**RE: WEAVER PROPERTY
PERC CERTIFICATION PLAN
3455 JENNINGS CHAPEL ROAD
WOODBINE, MD 21797**

Weaver Property is a 4.99496 acre lot, located on the east side of Jennings Chapel Road, approximately 2,800 feet south of the intersection of Jennings Chapel Road and Hipsley Mill Road, near Damascus, as shown on Howard County Tax Map 020, Grid 05, Parcel 0099. The revised Perc Certification Plan are being submitted for review along with responses to your comment email, dated March 05, 2025, which follows:

PERC CERTIFICATION PLAN
Weaver Property

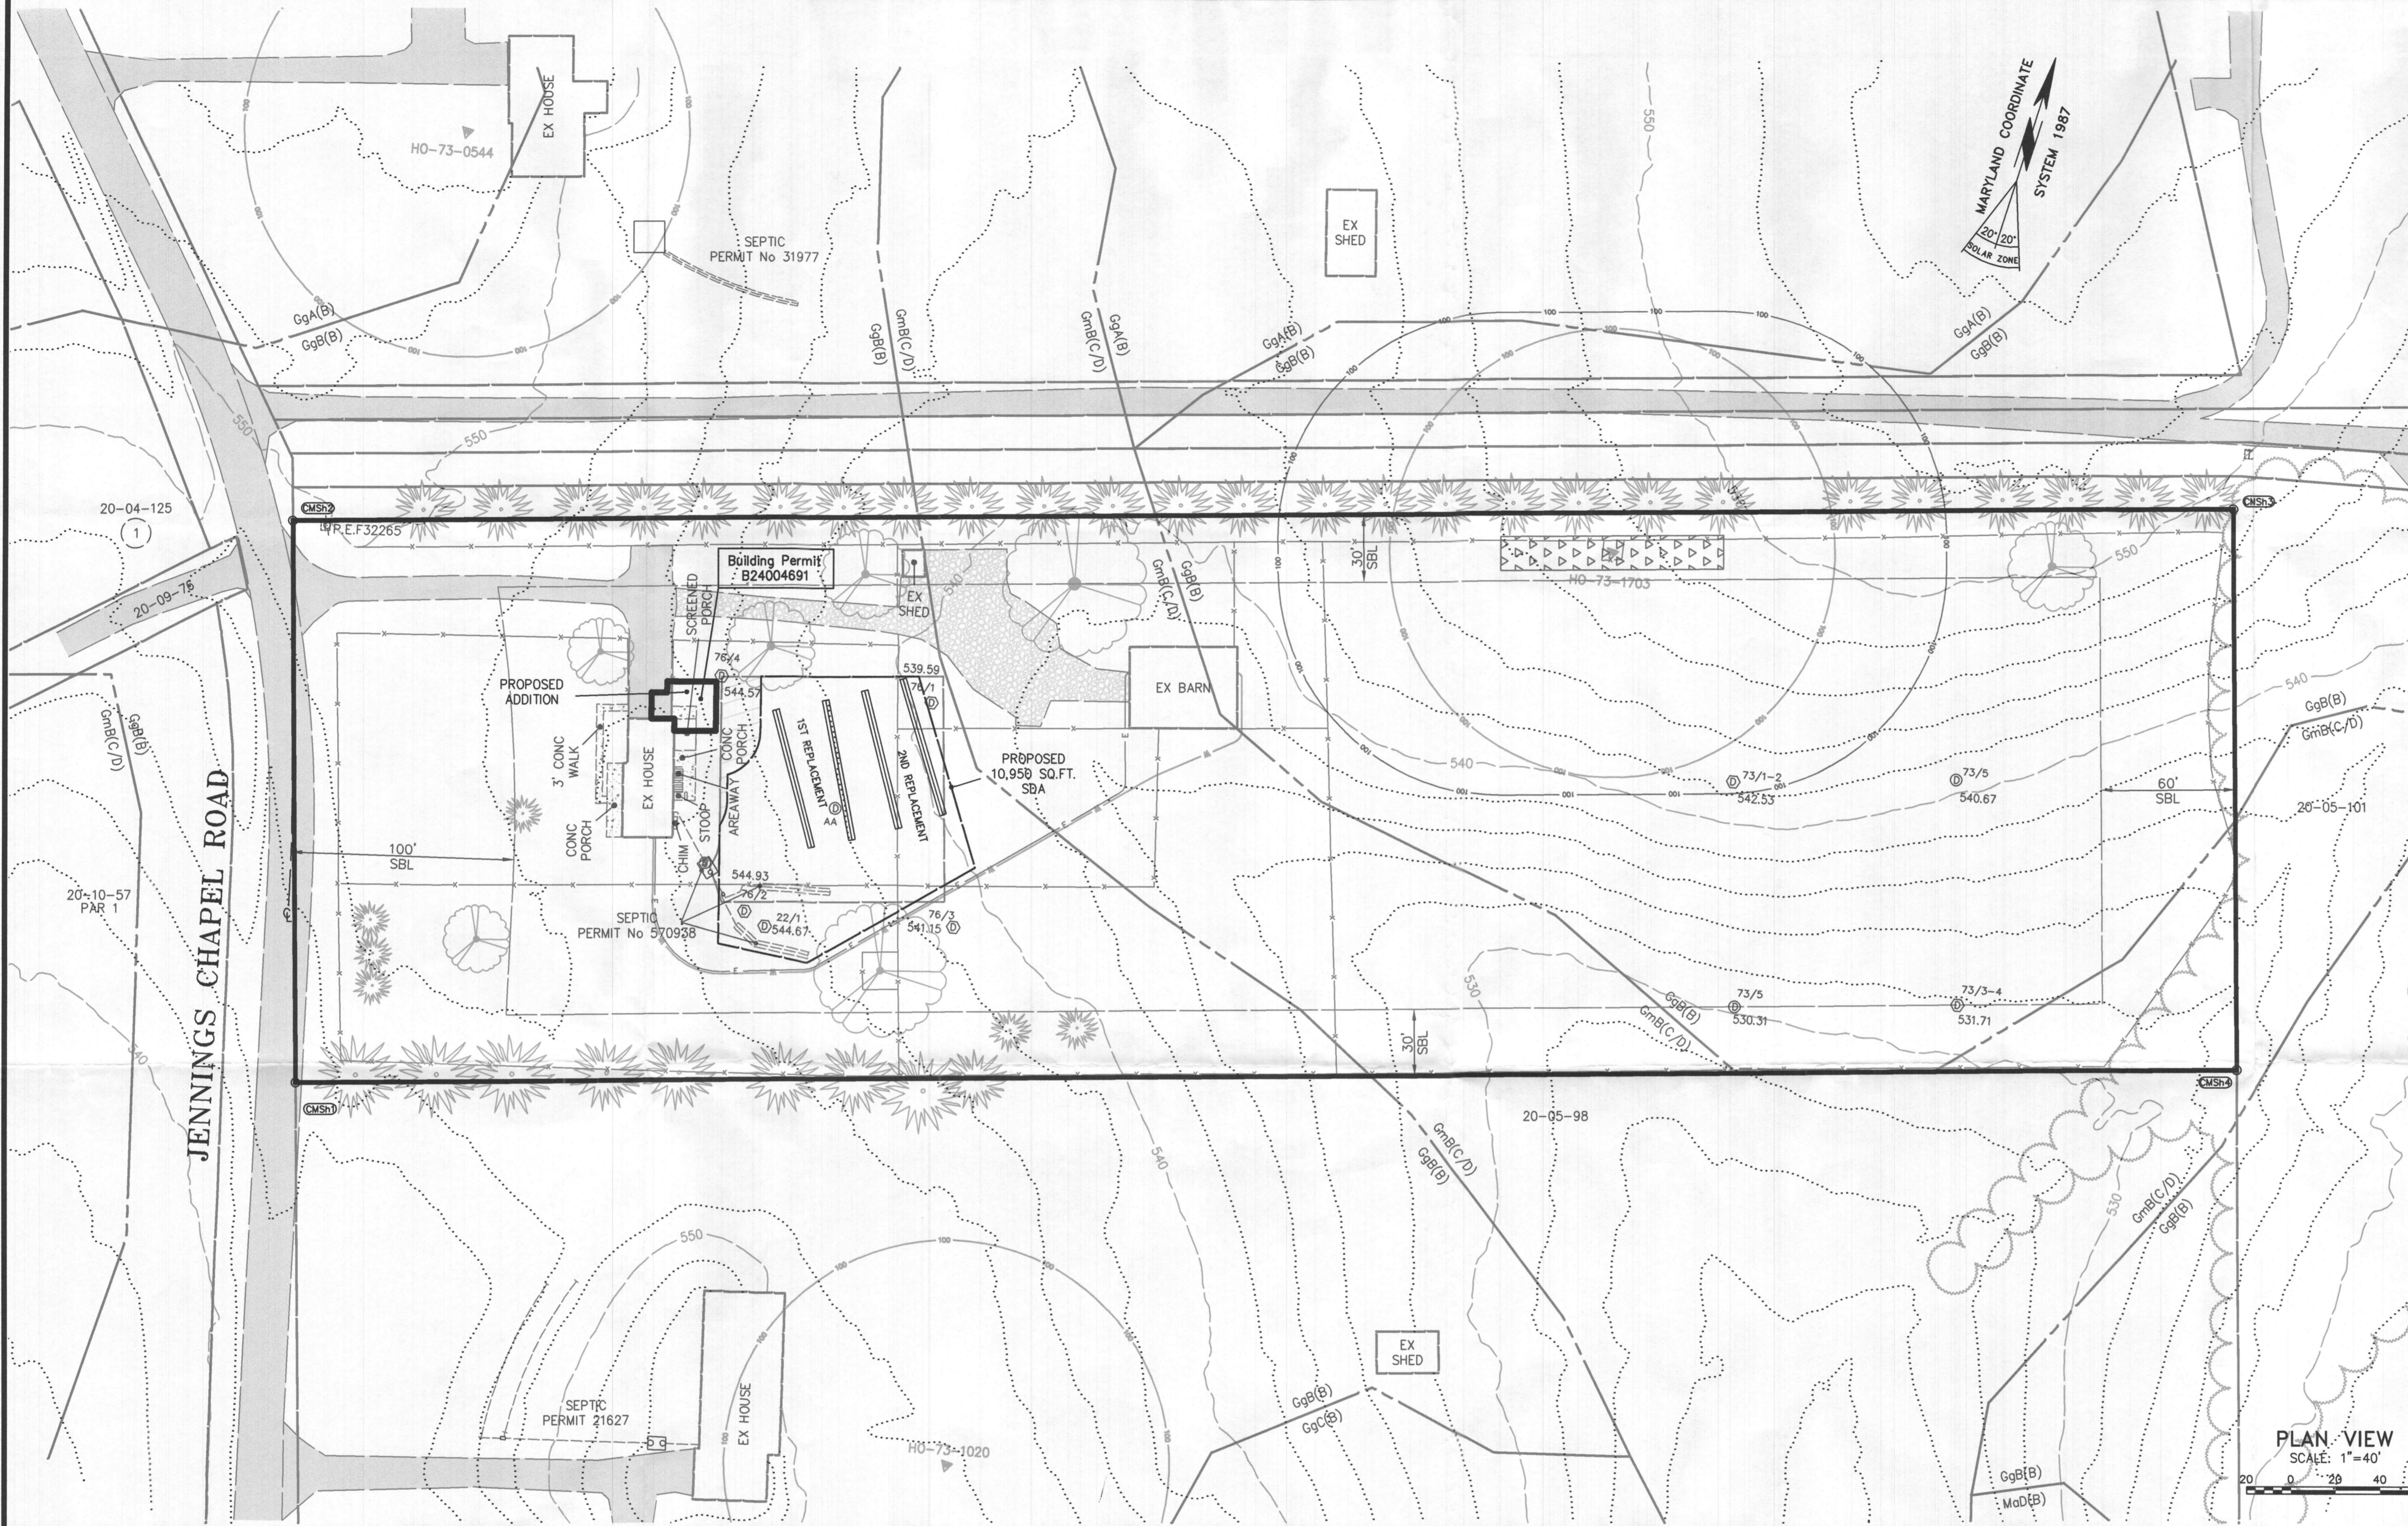
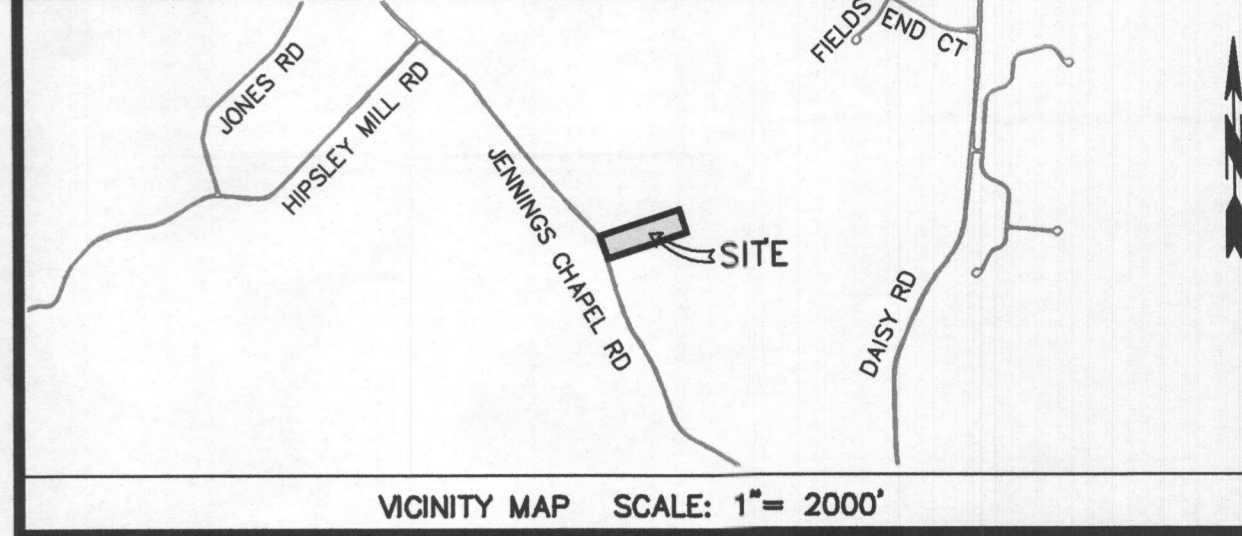
Both the water and electrical lines must be abandoned and removed from the proposed SDA prior to signature of the perc cert plan. We also need documentation regarding the size and condition of the septic tank. Additionally, please plot perc test holes# AA on the plan (See attached sheet for location of test hole). Lastly based on Kevins site visit notes, the trench data / calculations are as follow:

I wanted to follow-up on our conversation from yesterday regarding the trench length. I spoke to my coworker Kevin, and he recalls measuring the *upper trench* with the contractor to be 24 feet long. If the contractor recalls a different upper trench length, please have him put it in writing on his business letterhead. He also mentioned that the water and electrical lines were not field located at the time of the site inspection, so please have that done with a note on the plan. Please show a 5 foot buffer on either side of the water/electrical lines.

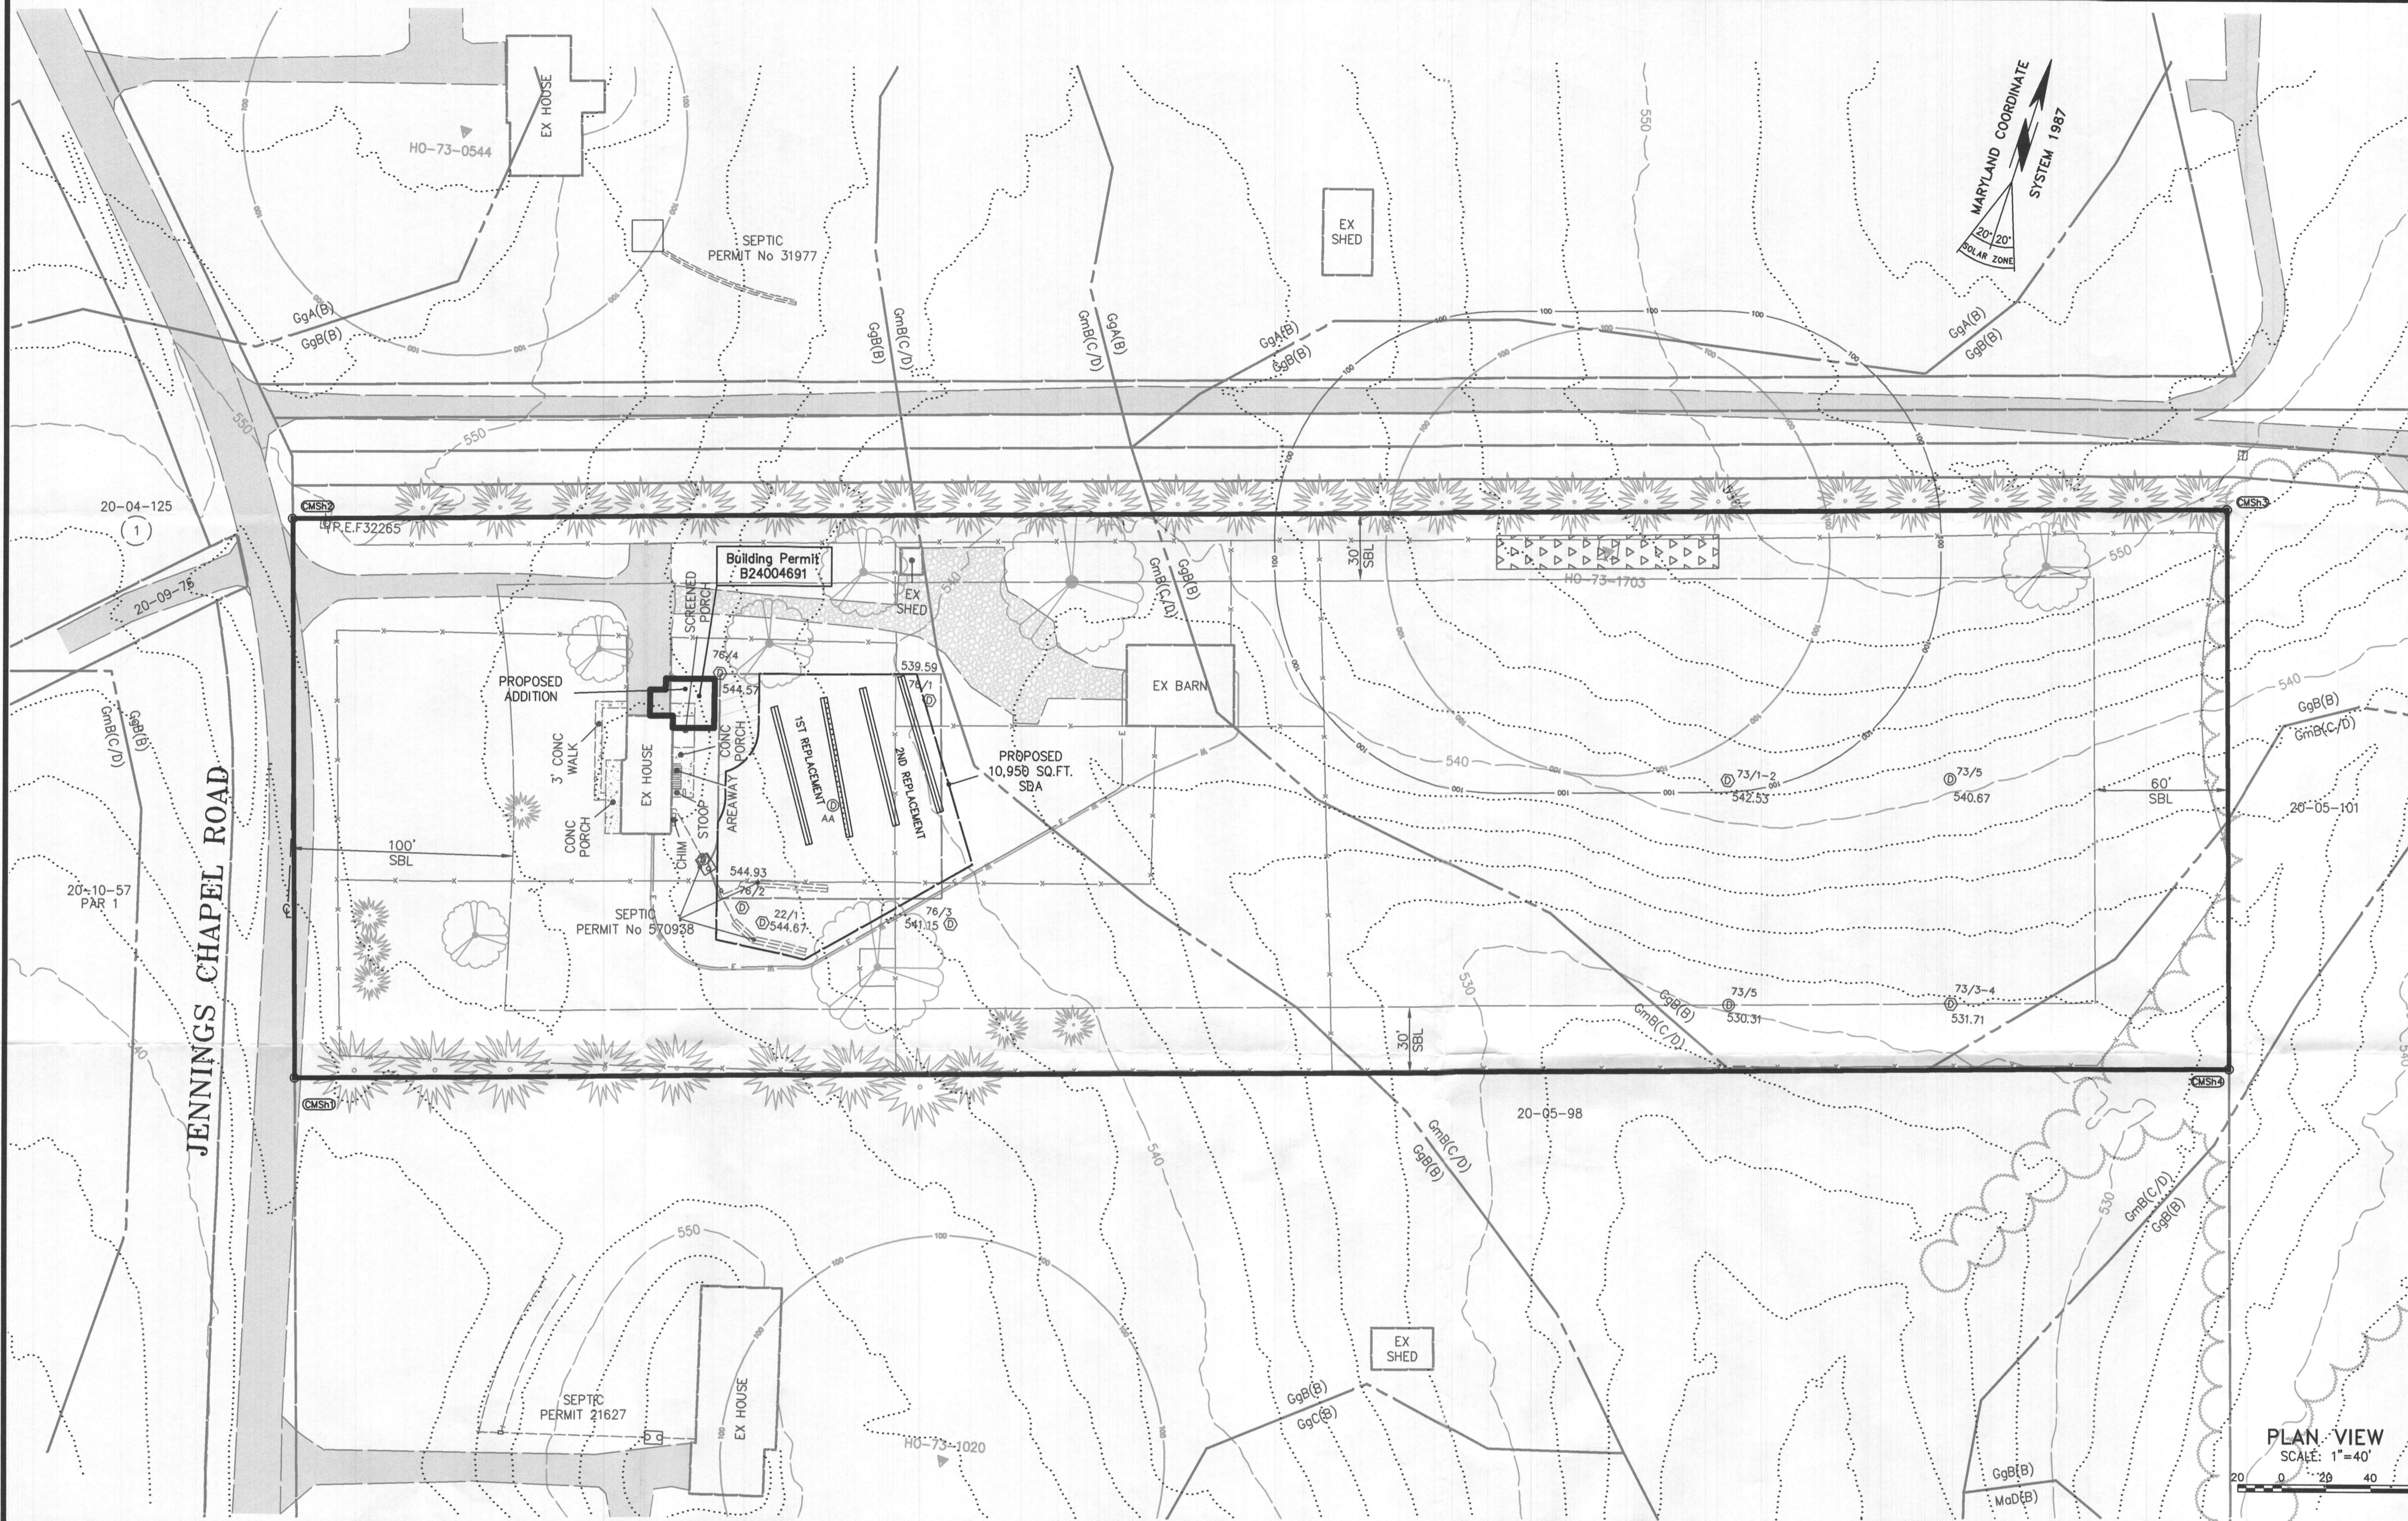
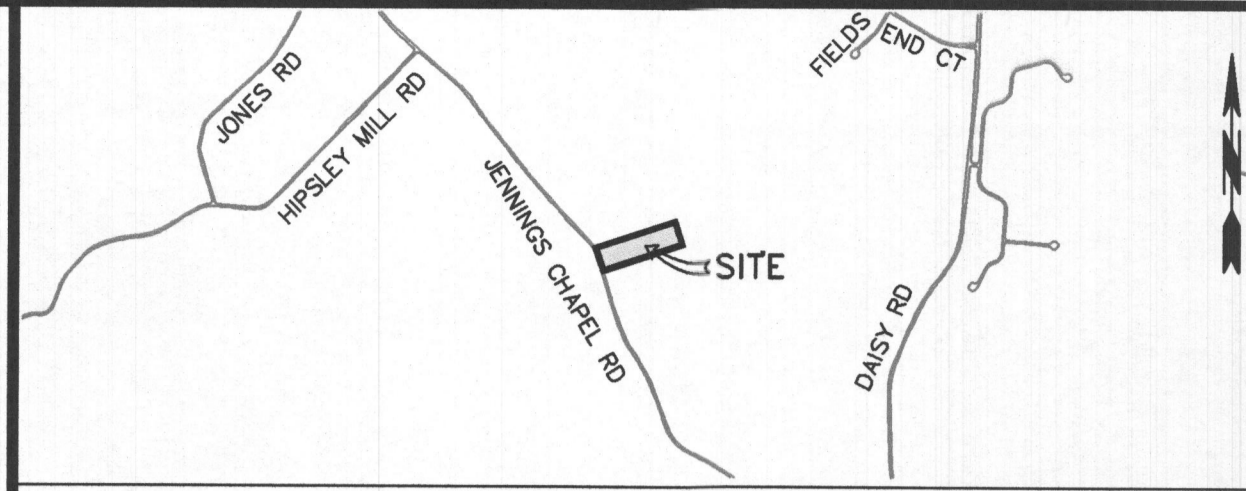
1. *Drop note #12 since we have a system large enough to accommodate a 4 bedrooms and your showing replacement systems within ther proposed area.*

2. *Add note, the septic components were field located and are accurately shown.*

3. *Add note, the water and electrical lines to the barn were field located and are accurately shown.*

4. *Delete legend symbol for proposed test.*

5. *Add address # to each lot shown. You could place it inside the house foot print.*

1. Drop note #12 since we have a system large enough to accommodate a 4 bedrooms and your showing replacement systems within the proposed area.
2. Add note, the septic components were field located and are accurately shown.
3. Add note, the water and electrical lines to the barn were field located and are accurately shown.
4. Delete legend symbol for proposed perc test.
5. Add address # to each lot shown. You could place it inside the house foot print.

Revised as directed.

Revised as directed.

Revised as directed.

Revised as directed.

Which number should be placed on each lot? The premise address or mailing address? If it is just a street number then something to qualify the meaning would be required. As I stated in my response letter, dated February 18, 2025, we qualify and place the Tax Map, Grid and Parcel numbers (20-05-101) on each adjoining property and the associated tax account ID, premise address, owner(s), mailing address and title deed reference are located in the Adjoining Property Owner Information located in the lower left hand corner of the submitted Perc Certification Plan. The title of the plan, owner/developer, Tax Map, Grid and Parcel, current zoning, and election district are shown in the Title Block, located in the lower right, with the all the same information as an adjoiner in the Property Owner Information chart in the lower left corner. This includes information as shown on the Maryland State Department of Assessments and Taxation which is more than just a street number.
